From: Rosefield Solar
Subject: EN010158 - Rosefield Solar Farm - deadline 1 submission

<https://nsip-documents.planninginspectorate.gov.uk/published-documents/EN010158-000242-6.4%20Environmental%20Statement%20Volume%204%20Appendix%2010.5%20-%20Residential%20Visual%20Amenity%20Assessment.pdf>

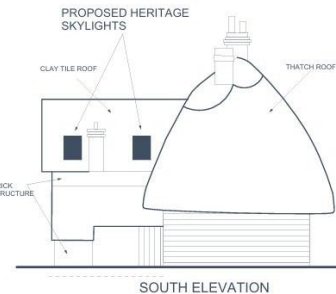
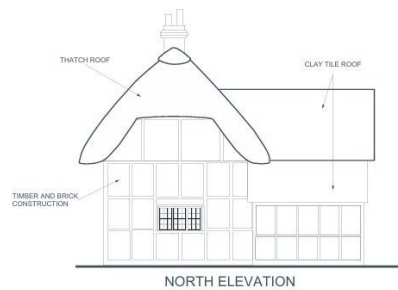
I have reviewed the visual material submitted with the application and find the photographs and photomontages to be highly unrealistic representations of how the human eye perceives the landscape. Several of the images appear to have been taken from deep within interior rooms or from positions set far back from windows, which artificially narrows the field of view. This is not how people experience a view in real life.

I work professionally in film and television, and I am very familiar with the limitations of camera optics. A camera has a significantly reduced field of vision compared to the human eye and compresses distance in a way that makes large structures appear smaller and less intrusive than they would in reality. The applicant's chosen viewpoints and photographic techniques therefore under-represent the true visual impact of the proposed development. As a result, the submitted images cannot be considered an accurate or reliable basis for assessing landscape or heritage effects

Because of my work in film and television, I am trained to evaluate how lenses, focal lengths, and camera positioning affect perceived scale. The techniques used in the applicant's images appear to minimise the apparent height and massing of the development, which would not reflect how a person standing at that location would actually experience the view.
